SIB 51 12 24

ELECTRIC SUNSHADES FOR THE REAR DOORS DO NOT FUNCTION OR ARE WAVY 2026-05-04

This Service Information Bulletin (Revision 1) replaces SI B51 12 24 dated June 2024

Procedure

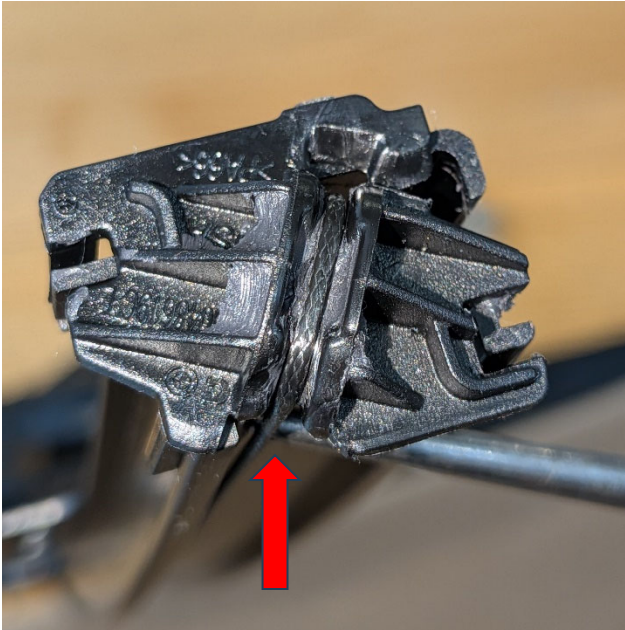
Incorrect routing of the cable.

With the use of a blunt hook tool. Pull lightly the cable out of its incorrect location.

Guide cable back into its channel.
